# DREHID WIND FARM AND SUBSTATION SID

## Responses to Submissions and Observations

North Kildare Wind Farm Limited

P25273-FT-XX-XX-RP-XX-0002

**Figure 2-4: Zoomed-in, and full hardstand detail reproduction of Figure 10.8 from the EIAR**

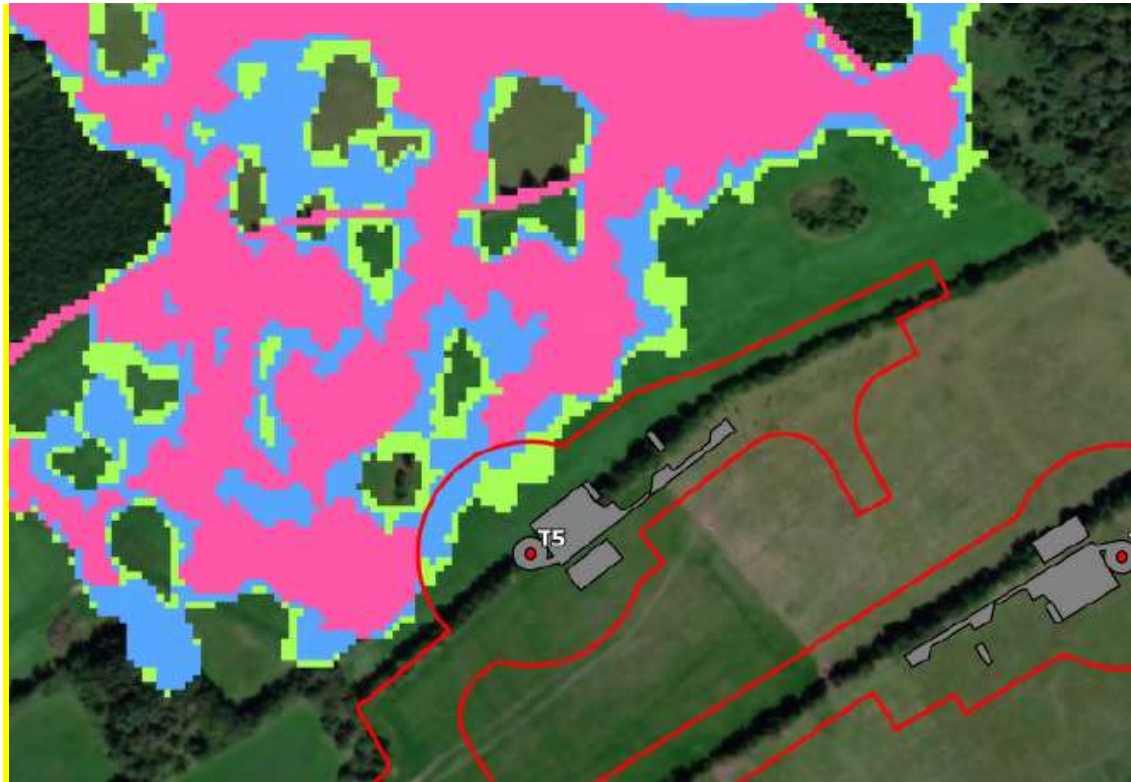
The Water Services Department state that T5 and T6 are within National Indicative Flood Map (NIFM) flood extents zone A and B. We would like to clarify that T5 is not within any of the NIFM flood extents (see Figure 10.8 of the EIAR). It is possible that the Water Services Department misinterpreted the redline boundary as the footprint of the infrastructure, as the redline boundary in the vicinity of T5 does lie within NIFM flood extents. For clarity, we have reproduced Figure 10.8 from the EIAR, this time including the details of the turbine hardstandings for avoidance of doubt of their extents, and zoomed to such a scale that it can clearly be observed that T5 does not lie within the NIFM flood extents.

It is true that the proposed location for T6 is situated within NIFM flood extents. Due to its location within indicative flood zones, a 2-D flood model was run for the area using HEC-RAS flood modelling software, and a high-resolution data terrain model (DTM) acquired in 2023. The flood model confirmed that flood extents for a 1-in-100 year flood event would extend over the T6 location, as shown in Figure 2-5:

As detailed within the EIAR, to mitigate against the potential for flood events impacting on the T6 turbine, the ground will be raised locally at the T6 location, so that the turbine foundation and hardstanding has a finished level that is at least 300 mm above the modelled flood level. The finished level of the hardstanding will be 79.5 mOD as can be seen on planning drawing P22-242-0300-0006, which exceeds the 300 mm above the modelled flood level.

Raising the ground locally to elevate the T6 foundation and hardstanding will displace a volume from the flood capacity in the area, and therefore flood “compensation” must be provided to return the flood capacity to the same as pre-development. This will be achieved by providing a “flood compensation area” immediately adjacent to the T6 hardstanding, as shown on planning drawing P22-242-0101-0033. The flood compensation area will comprise a depression in the local ground, excavated to 1.5 m below existing ground level, to cover an area as shown in the planning drawing P22-242-0101-0033 which will provide a compensation of flood capacity to cancel the volume displaced by raising the T6 foundation and hardstanding. The result of this is that flood extents in the local area are unchanged for a given flood event, as the capacity for the land to absorb flood water remains the same post-development.
